EXHIBIT LIST

Reference No: HOL/10018

Petitioner: EUSTON STANDARD PACK

The implications of HS2 Euston Action Group's proposal to locate the main HS2 London terminus at Old Oak Common

'Double deck up' options

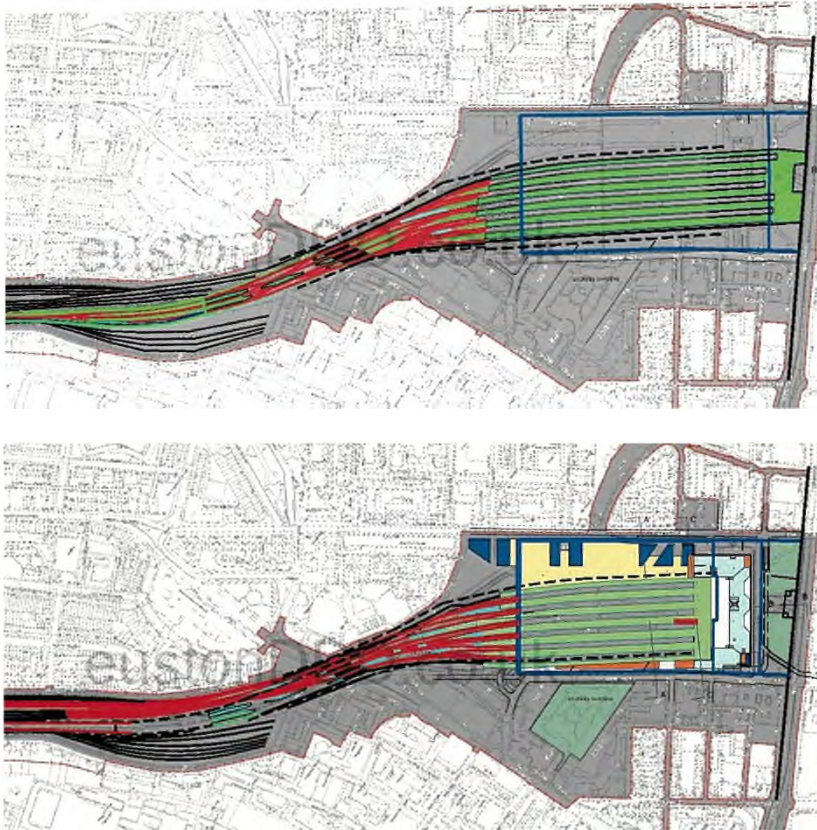
- Extremely complex to build while maintaining train services
- Residential areas affected by high level tracks
- Rejected because of complexity, cost and duration of works.

Compliant DDD2 layout

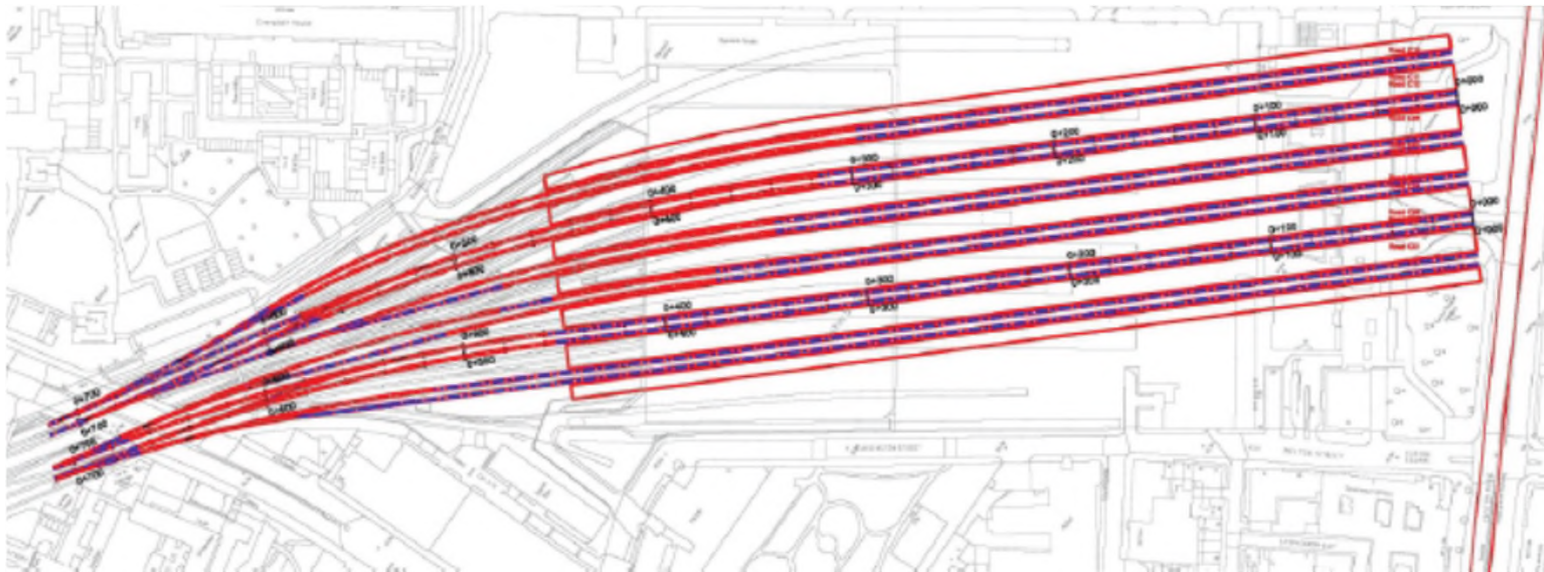
- Platforms encroach into Euston Square Gardens
- Station closed during construction
